PRODUCT CHANGE NOTIFICATION (PCN)

AMJG0808-0100-GYB-26 MODULAR CABLE

CHANGE NOTIFICATION:	PCN 20220425_AMJG0808-0100-GYB-26
DESCRIPTION OF CHANGES:	CHANGE OF DATA SHEET CHANGE OF DATA SHEET New Draw.-No. ASS_7947_CArev02
REASON FOR CHANGE:	CHANGE OF PRODUCT LOCATION CHANGE OF PRODUCT LOCATION
KEY CHARACTERISTICS OF CHANGE:	Details see page 3
PRODUCTS AFFECTED:	AMJG0808-0100-GYB-26
DATE OF CHANGE AND IMPLEMENTATION:	CHANGE: WEEK 18 / YEAR 2022 IMPLEMENTATION: 25/4/2022
RESPONSE:	NO RESPONSE TO THIS NOTIFICATION IS REQUIRED

AMJG0808-0100-GYB-26
DOCUMENT: DRAWING

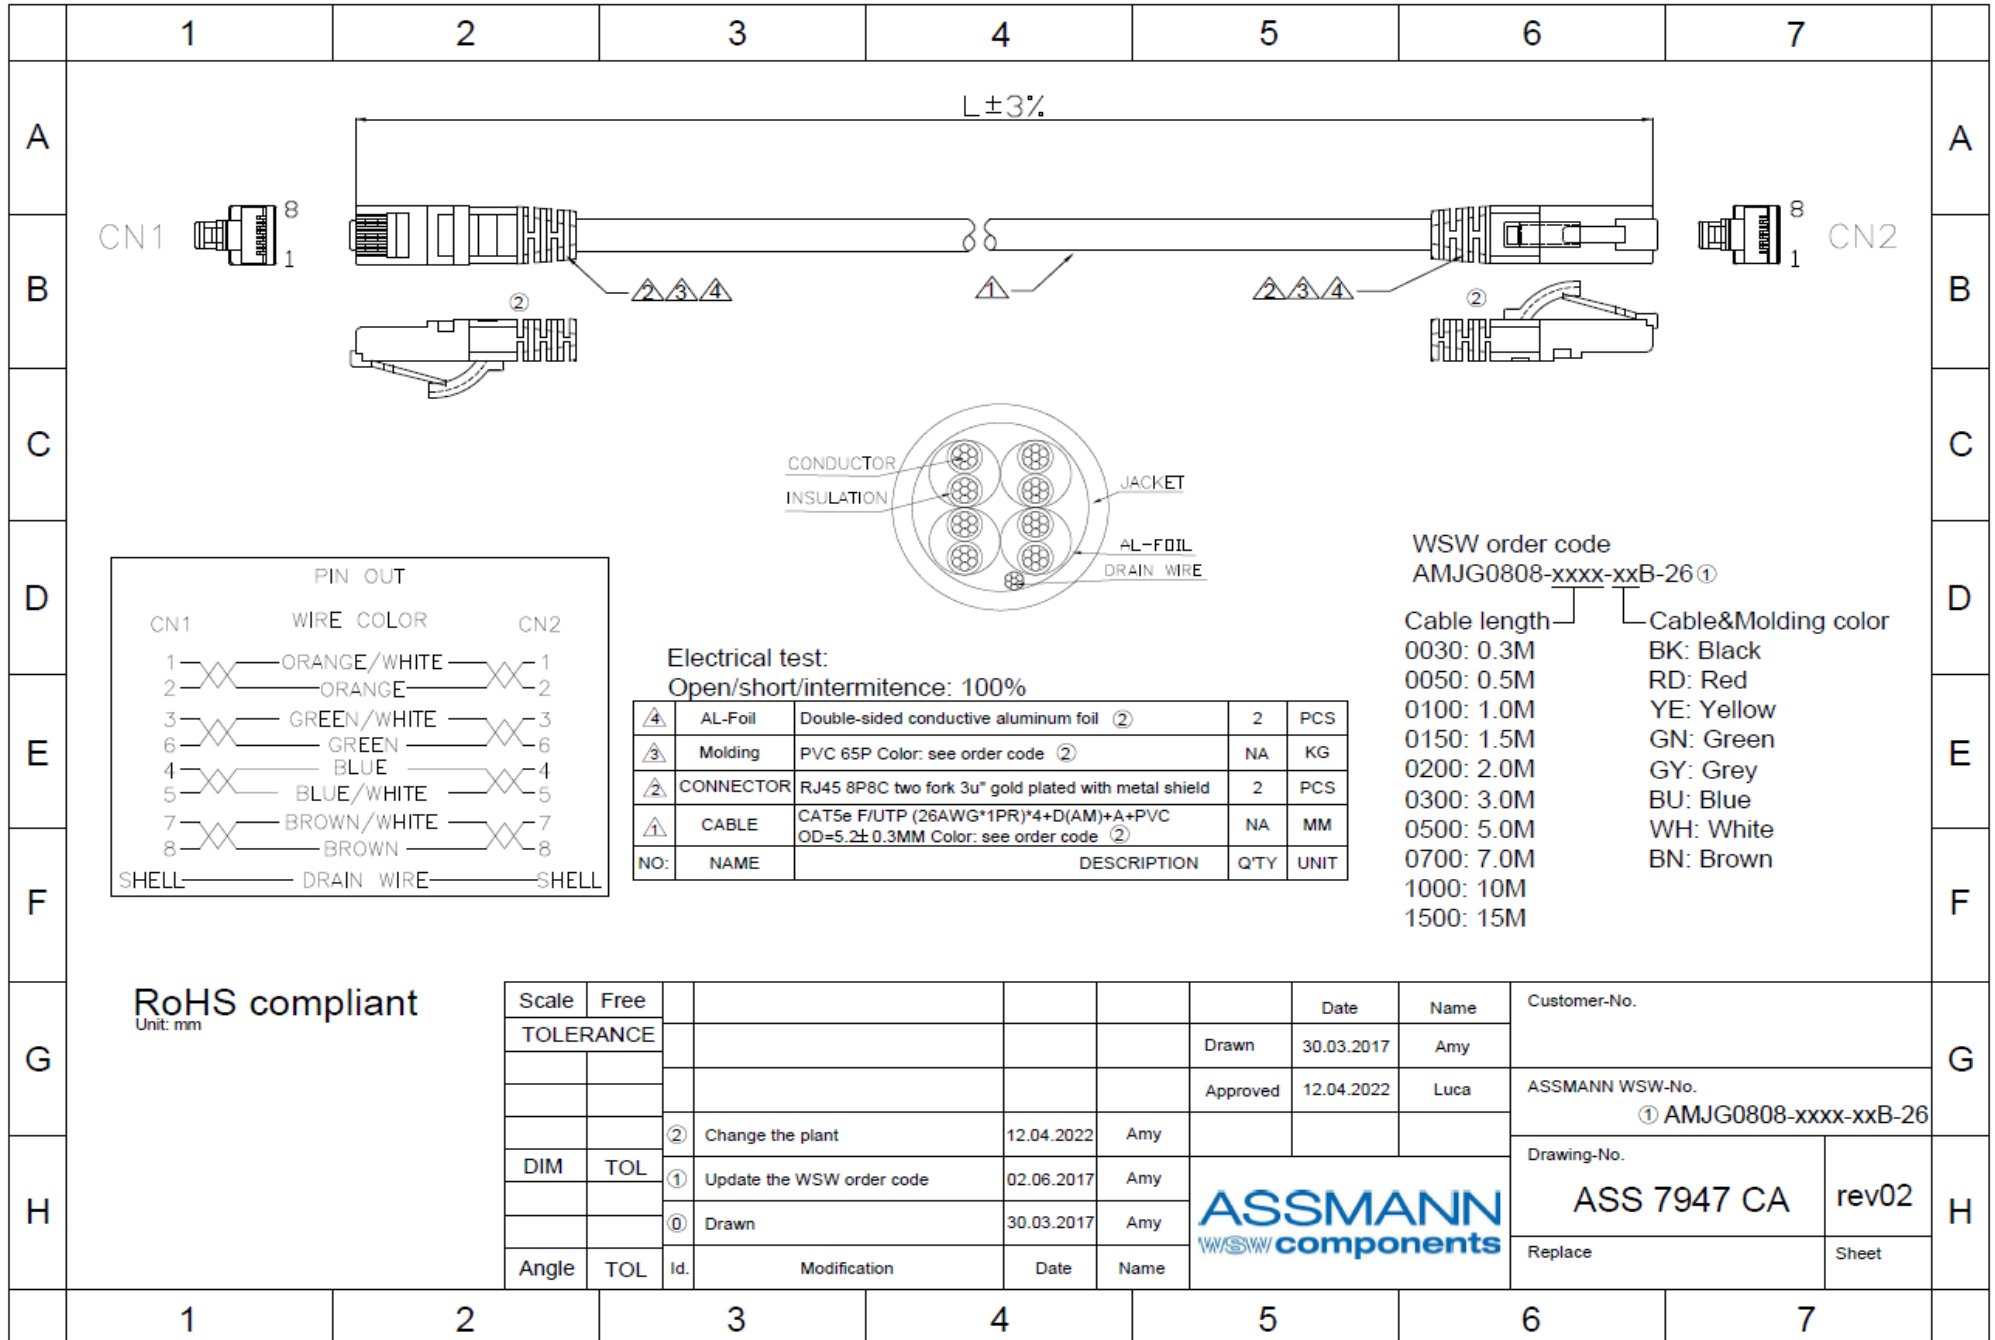
ASSMANN WSW P/N	Drawing Number		ASSMANN WSW P/N	Drawing Number
AMJG0808-0100-GYB-26	ASS_7947_CArev01	↔	AMJG0808-0100-GYB-26	ASS_7947_CArev02

AMJG0808-0100-GYB-26	OLD VERSION	AMJG0808-0100-GYB-26	NEW VERSION																																													
<p>Appearance</p>		<p>Appearance</p>																																														
<p>BOM</p> <table border="1"> <thead> <tr> <th>NO:</th> <th>NAME</th> <th>DESCRIPTION</th> <th>Q'TY</th> <th>UNIT</th> </tr> </thead> <tbody> <tr> <td>③</td> <td>Molding</td> <td>PVC 45P Color: see order code</td> <td>NA</td> <td>KG</td> </tr> <tr> <td>②</td> <td>CONNECTOR</td> <td>RJ45 8P8C two fork 3u" gold plated with metal shield</td> <td>2</td> <td>PCS</td> </tr> <tr> <td>①</td> <td>CABLE</td> <td>CAT5e FTP (26AWG*1PR)*4+D+A+PVC OD=5,2±0,3MM Color: see order code</td> <td>NA</td> <td>MM</td> </tr> </tbody> </table>		NO:	NAME	DESCRIPTION	Q'TY	UNIT	③	Molding	PVC 45P Color: see order code	NA	KG	②	CONNECTOR	RJ45 8P8C two fork 3u" gold plated with metal shield	2	PCS	①	CABLE	CAT5e FTP (26AWG*1PR)*4+D+A+PVC OD=5,2±0,3MM Color: see order code	NA	MM	<p>BOM</p> <table border="1"> <thead> <tr> <th>NO:</th> <th>NAME</th> <th>DESCRIPTION</th> <th>Q'TY</th> <th>UNIT</th> </tr> </thead> <tbody> <tr> <td>⚠</td> <td>AL-Foil</td> <td>Double-sided conductive aluminum foil ②</td> <td>2</td> <td>PCS</td> </tr> <tr> <td>⚠</td> <td>Molding</td> <td>PVC 65P Color: see order code ②</td> <td>NA</td> <td>KG</td> </tr> <tr> <td>⚠</td> <td>CONNECTOR</td> <td>RJ45 8P8C two fork 3u" gold plated with metal shield</td> <td>2</td> <td>PCS</td> </tr> <tr> <td>⚠</td> <td>CABLE</td> <td>CAT5e F/UTP (26AWG*1PR)*4+D(AM)+A+PVC OD=5,2±0,3MM Color: see order code ②</td> <td>NA</td> <td>MM</td> </tr> </tbody> </table>		NO:	NAME	DESCRIPTION	Q'TY	UNIT	⚠	AL-Foil	Double-sided conductive aluminum foil ②	2	PCS	⚠	Molding	PVC 65P Color: see order code ②	NA	KG	⚠	CONNECTOR	RJ45 8P8C two fork 3u" gold plated with metal shield	2	PCS	⚠	CABLE	CAT5e F/UTP (26AWG*1PR)*4+D(AM)+A+PVC OD=5,2±0,3MM Color: see order code ②	NA	MM
